TITLE PIT MOUNTED HYDRAULIC SCISOR LIFT

CLIENT - ACCURATE INDUSTRIAL CONTROLS PVT LTD

DWG. NO. : NIHVA/20-21/0090 REV- R00

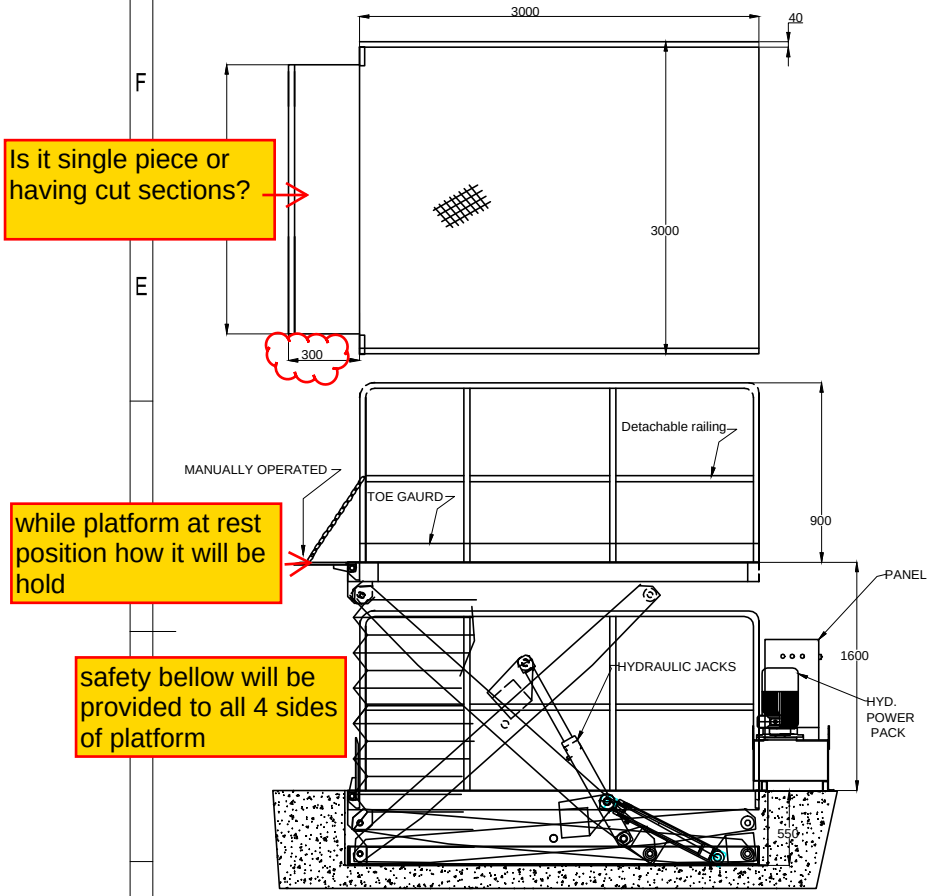
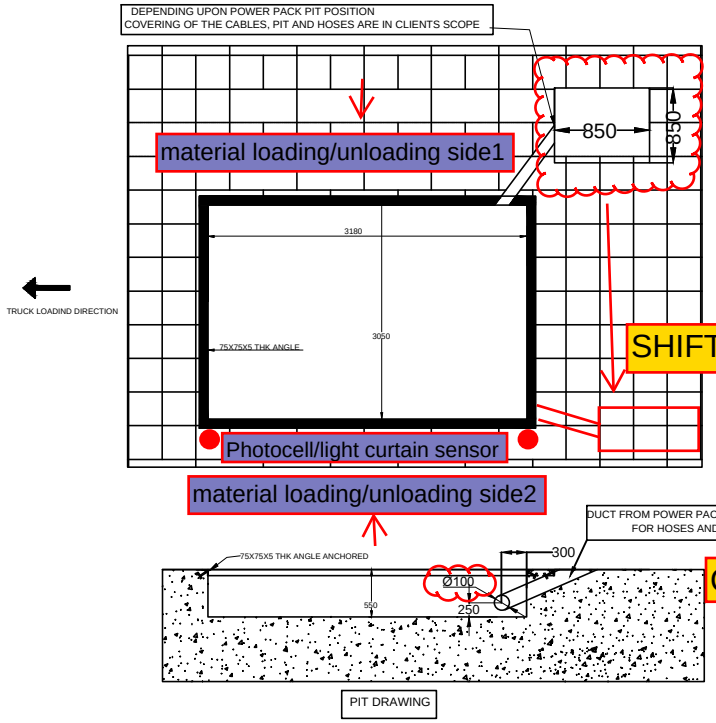
Is it single piece or having cut sections?

while platform at rest position how it will be hold

safety bellow will be provided to all 4 sides of platform

CAN WE USE 4" DUCT?

Is it 350mm or 300mm?
